Interactive comment on “Spatial pattern evaluation of a calibrated national hydrological model – a remote sensing based diagnostic approach” by Gorka Mendiguren et al.

Response to anonymous Referee #2

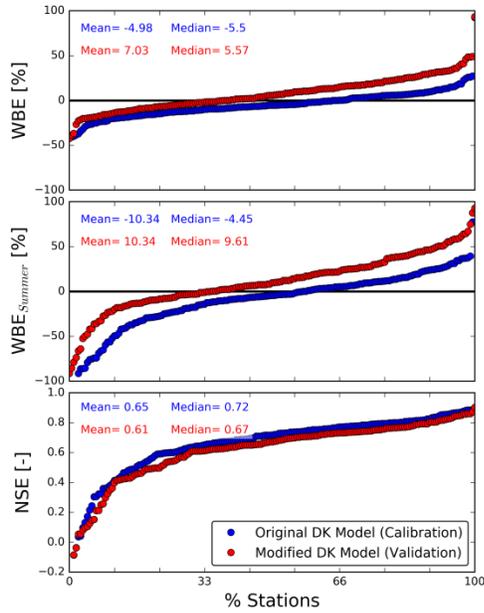
Section 3: Please consider to reorganize the structure (sub-sections) of Section 2. I found that it is quite difficult to understand and follow the sequence of each step of your methods.

We have decided to reorganize the structure following the reviewer recommendation. In the new manuscript we have divided the methods in three defined groups, one for the TSEB and a second one for the hydrological model and a third for the EOF, following a more logical sequence. This will also allow a more detailed theoretical description of TSEB as requested by the reviewers.

The scheme for the new methods section in manuscript looks as follows:

Ground Water heads:

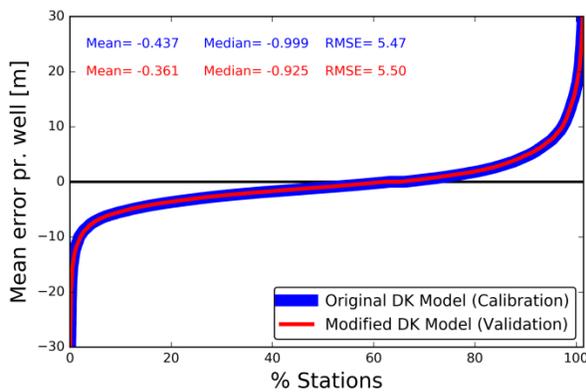
Page 4, lines 10-11: You have discharge and groundwater head measurement data. Could you please evaluate the results of your improved model to these data?

Reply: Reviewer 1 has pointed to this and we agree that this information should be included in the manuscript. To reduce the size of the response, please read the response give to reviewer 1 in the last comment before the technical corrections.

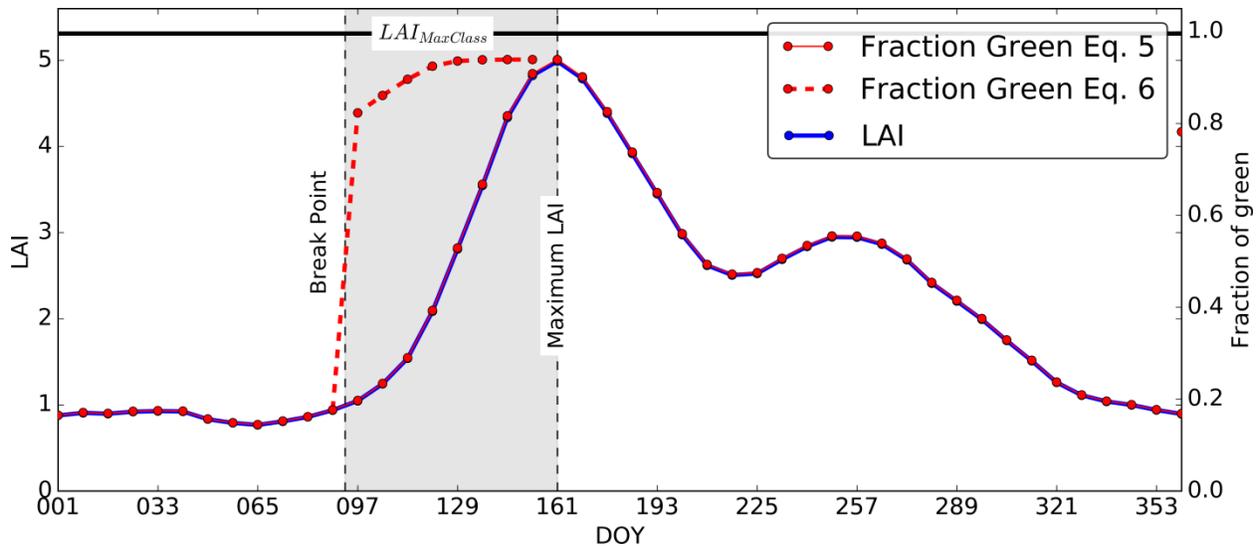
Page 5, line 27 to Page 6, line 9: Please rewrite this part. I hardly follow it. And can you please justify this assumption to the reality?

Reply: We agree with the reviewer that the explanation of what we conducted to retrieve the F_g was very difficult to understand and read (in addition we also had put in a wrong equation). We have completely rewritten this section hoping to make it clearer for the reader. The new text says:

This substitution is only conducted during part of the phenological year, more specifically for the period defined by an increase in 20% increase in LAI compared to the winter low and until the to the time at which LAI reaches its maximum (see next Figure).”

We believe this assumption fits well with reality, since a given LAI value before and after senescence can have quite different F_g values. During the growing season most of the plant remains green, which is quite well represented with the modification including the exponential term in the equation. After the point, where vegetation has reached its maximum seasonal development (we assume at maximum LAI is maximum), senescence starts and more non-photosynthetically active regions start to appear in the plant, what is translated in lower F_g values.
